AGENDA
HANAHAN PLANNING COMMISSION MEETING
Thursday, January 6, 2022
6:30 P.M.

To: The Hanahan Planning Commission
Cc: Larry Sturdivant, Building Official; Ray Wrenn, the Wrenn Group, Lee Rodriguez, LFK Architects, LLC
From: Alexis Kiser, Planner/Economic Development Director
Date: December 27, 2021
Re: Bowen “Greenway” Site Plan Submittal

To: The Hanahan Planning Commission
Cc: Larry Sturdivant, Building Official; Ray Wrenn, the Wrenn Group, Lee Rodriguez, LFK Architects, LLC
From: Alexis Kiser, Planner/Economic Development Director
Date: December 26, 2021
Re: Bowen "The Landing" Site Plan Submittal

SITE PLAN SKETCH

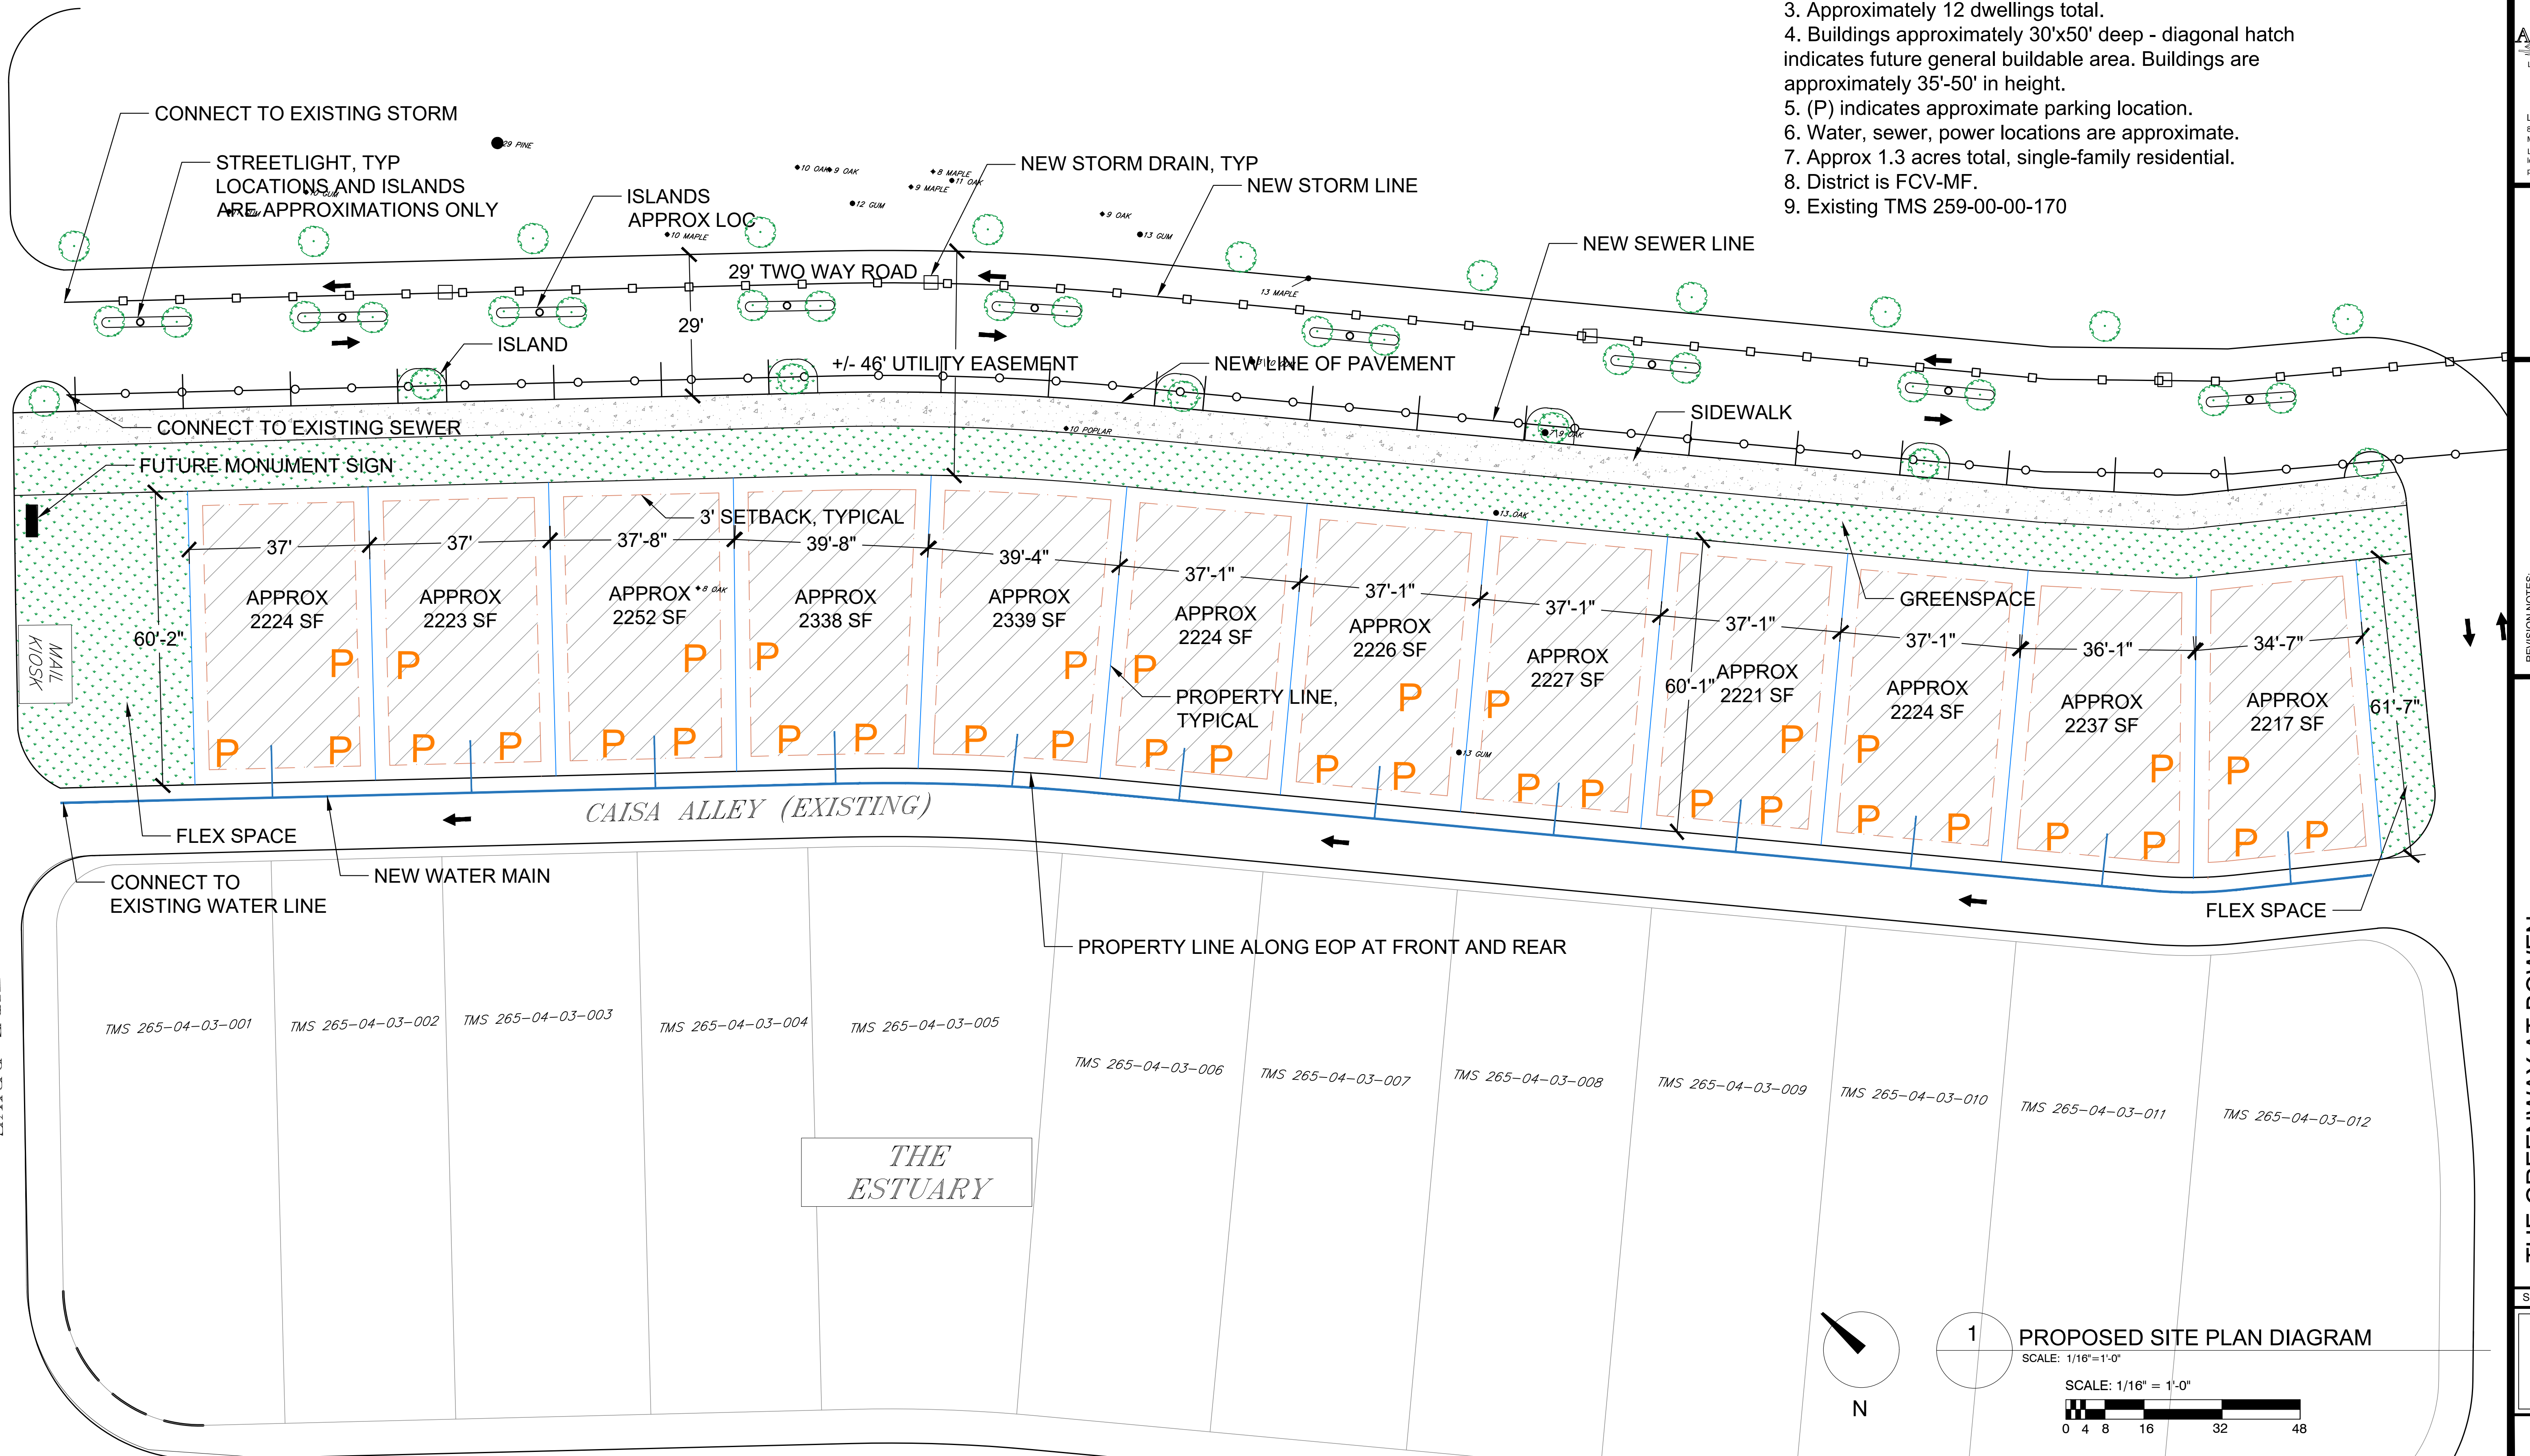
- a. The site plan appears to show that proposed storm water will tie into an exiting one. There will be a new storm line, sewer line, and water main to service the development.

- a. These items are indicated on the site plan with the exception of driveways. The proposed location for each lot appears to be indicated by "P" on the site plan, however, the general dimensions of driveways are **not** indicated.

6. The general location and approximate heights of all principal and accessory buildings and dimensions of structures.
 - a. The location and approximate heights of all principal buildings are shown on the site plan. It is not clear from the site plan if there will be accessory structures on each lot. Dimensions of structures are **not** provided.

9. The general location, character, size and height of all signs.
 - a. The site plan indicates a monument sign but does **not** indicate the character, size, or height of said sign.

- I. Dimensions for the sidewalk shown on the site plan.

1. Complete all requested corrections under the "1993 Zoning Ordinance Site Plan Requirements (Section 601.3) Requested Corrections" section, specifically items discussed in No. 4, 6, and 9.
2. Complete all requested corrections under the "Site plan Approval Requested Corrections (FCV PD, Type B Document)" section.

PROPOSED SITE PLAN SKETCH

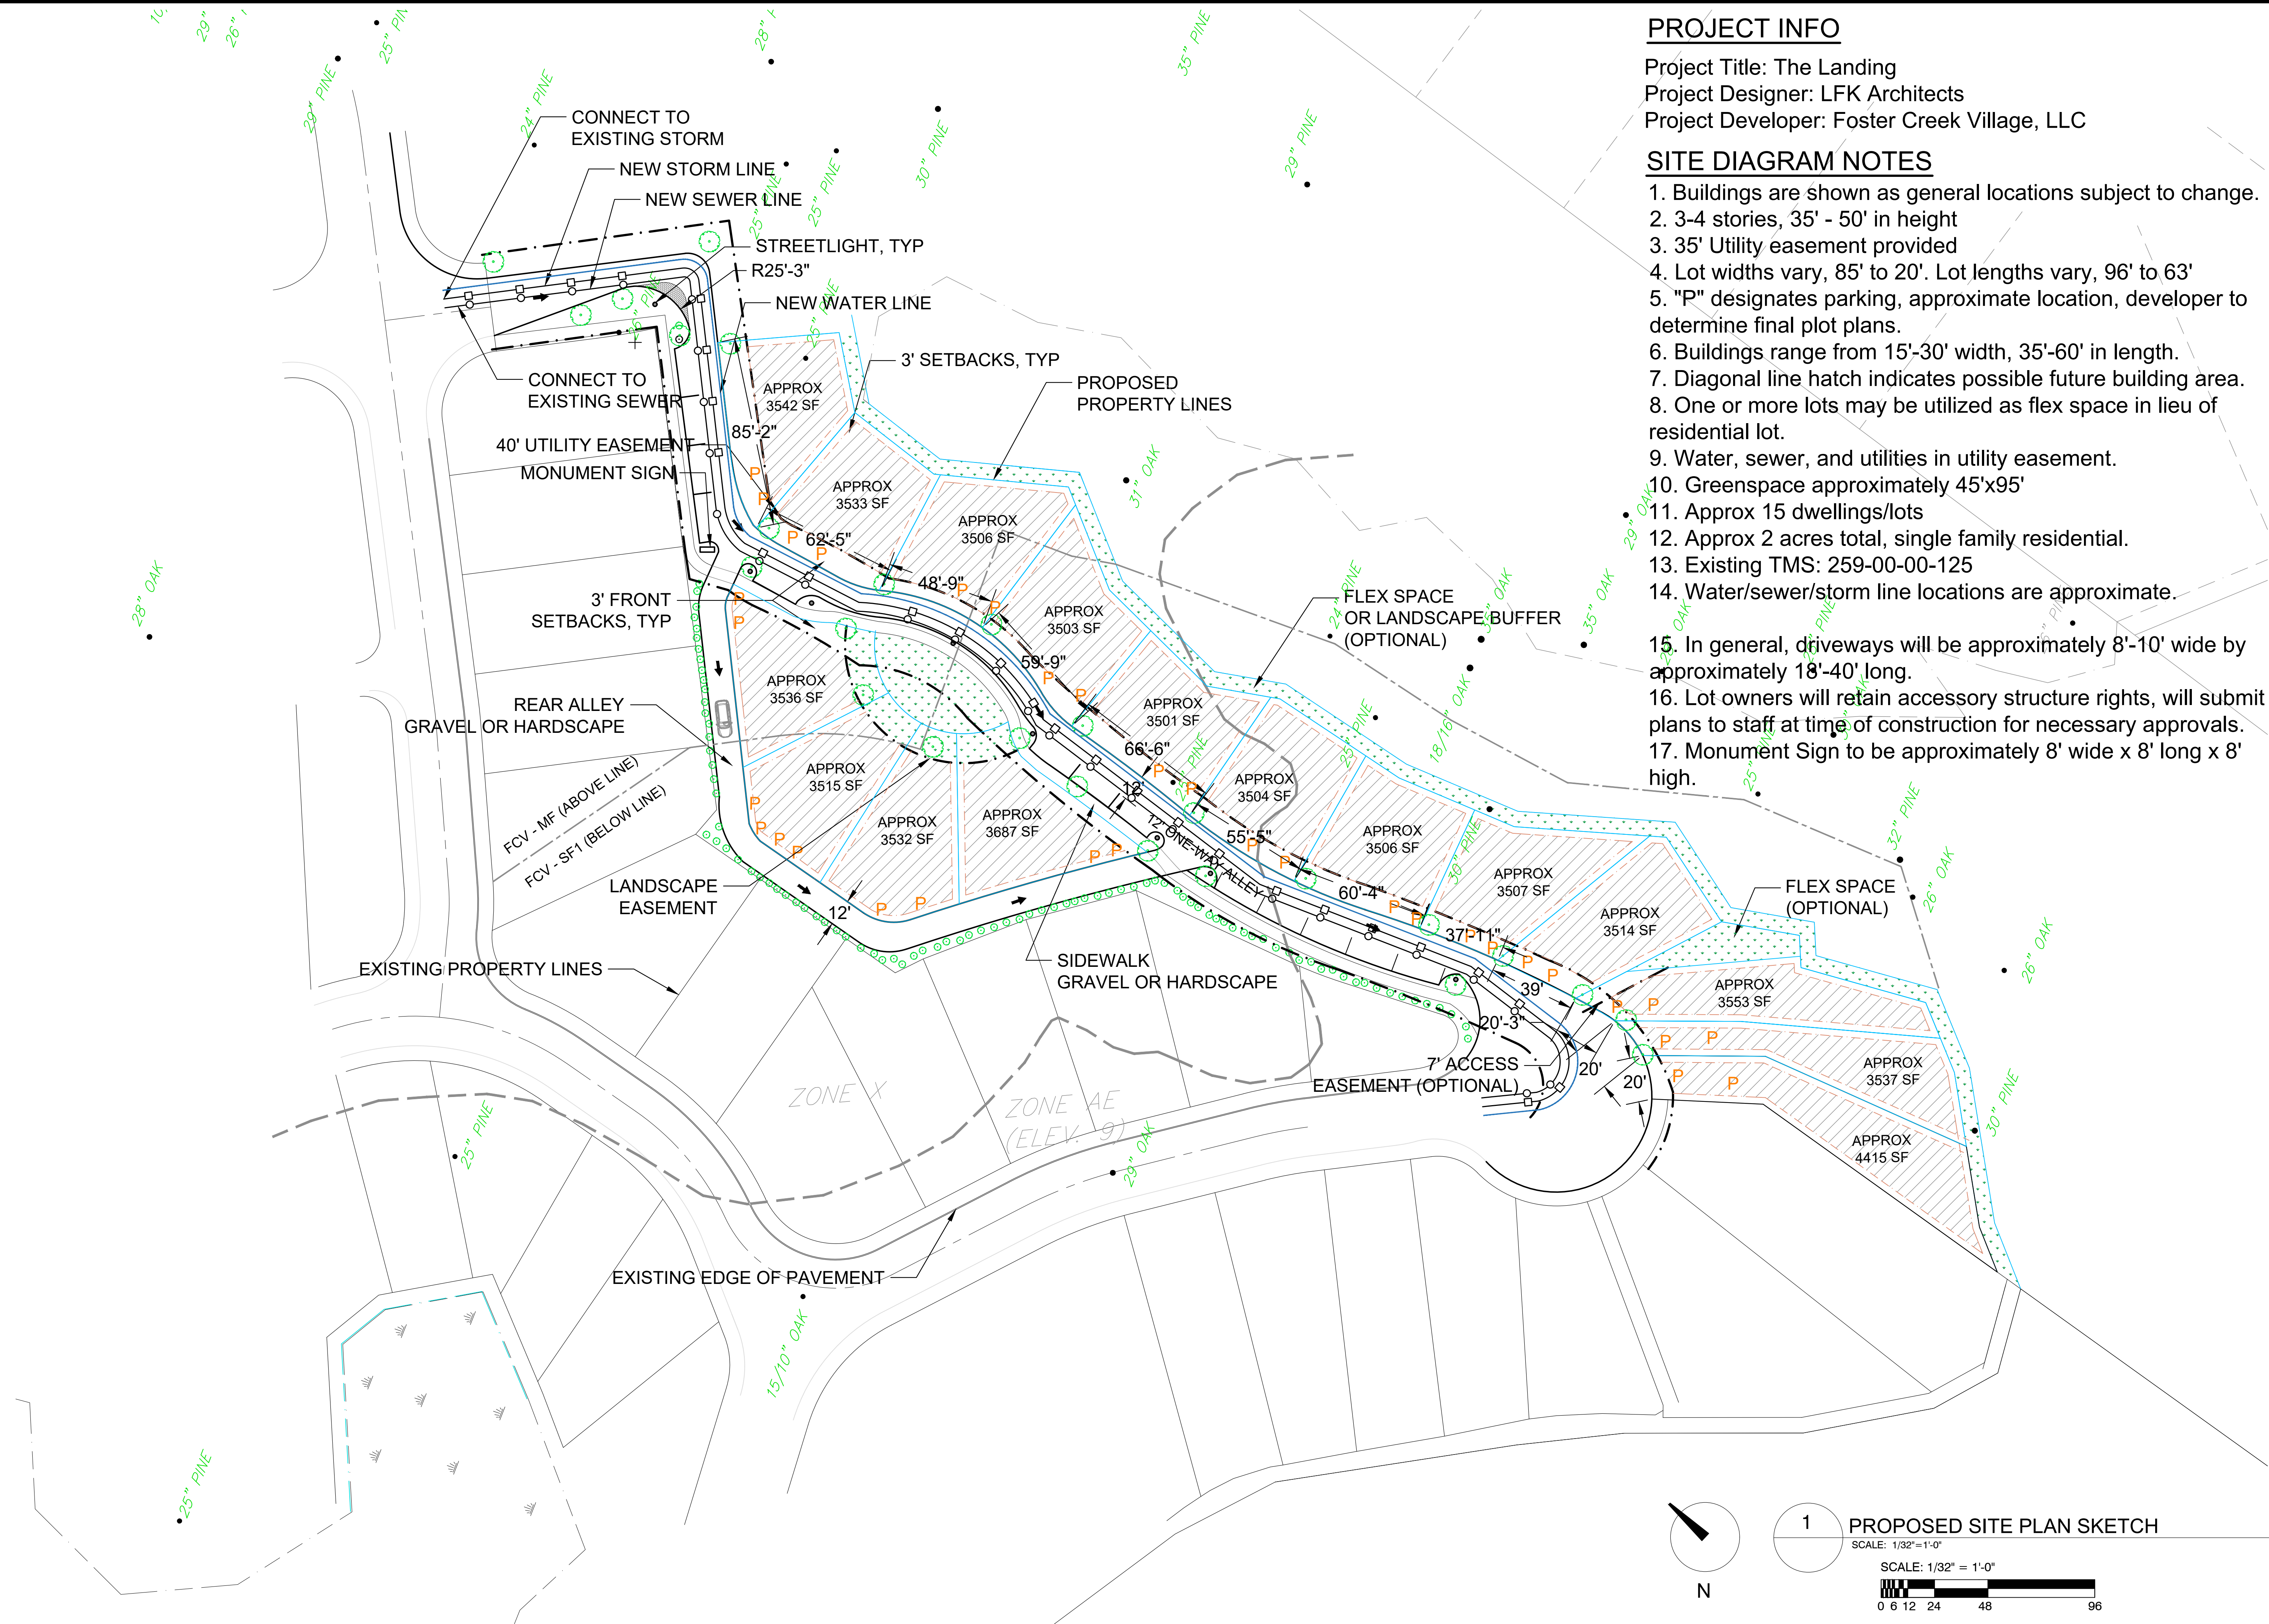
one or more lots may be utilized as flex space in the notes, however, only denotes one “flex space” lot on the site plan. It is not clear what the intended use of the “flex space” in this development will be. Additionally, the site plan indicates a flex space or landscape buffer at the east edge of the development; dimensions for this area is not provided on the site plan.

The single-family homes will be served by a single transportation right-of-way one-way alley that will be 12 feet wide with parking street parking in some areas. The width of the alley does not appear to include the necessary dimensions to accommodate vehicle parking and at these areas the alley way will be wider in those places. Additionally, there will be an additional rear alley to serve five single-family units. The applicant has indicated this will either be gravel or hardscape material. The site plan indicates approximately 42 parking spaces for the development. Sidewalks are indicated on the site plan and will be gravel or hardscape.

1. The proposed minimum lot size *does not* conform to the PD required minimum for FCV-SF1 (the lesser requirement of the two districts of the development) of 3,500 SF.
 - a. The site plan indicates that of the proposed 21 single-family residential lots proposed, only one lot meets this requirement.
2. Lots appear to conform to the PD's minimum 20-foot lot width requirement.
3. Density for the development is limited to 12 units per acre for the entire PD and open space requirements are calculated for the overall development.

- a. These items are indicated on the site plan with the exception of driveways. The proposed location for each lot appears to be indicated by "P" on the site plan, however, the general dimensions of driveways are **not** indicated.

5. Design Standards (F)(1) Streetscape (Pg. 6 of PD Document): "One canopy tree with a 2.5" caliper minimum diameter at breast height (DBH) spaced every 40' on center along both sides of all roadways shall be located within the private rights-of-way." These will need to be shown on the site plan or separate landscape plan.

5. Design Standards (G) Site Lighting (Pg. 7 of PD Document): “Site lighting will be required along all streets, and future site amenities. The style of lighting fixtures will complement the Project and ensure safe travel during nighttime hours. Low voltage bollard or pole-mounted lighting may be introduced throughout the interconnecting trail systems. Future lighting may include photocell timers, which will ensure minimal disturbance to surrounding wildlife and neighborhoods. Lighting fixtures on rights of way will meet applicable design character and emphasize the pedestrian feel throughout the Project. Final location and style of all lighting fixtures will be determined at a later date and approved during the preliminary plat approval process.”

Address the minimum lot size conformance referenced in the Development Standards table on page 13 of the Foster Creek Village PD Document.

1. Applicant must correct all proposed lot sizes to be in accordance with the "FCV-SF1" district, as stated in the "General Conformance Analysis" section, specifically No. 1 (minimum lot size).
2. Complete all requested corrections under the "1993 Zoning Ordinance Site Plan Requirements (Section 601.3) Requested Corrections" section, specifically items discussed in No. 4, 6, and 9.
3. Complete all requested corrections under the "Site plan Approval Requested Corrections (FCV PD, Type B Document)" section.
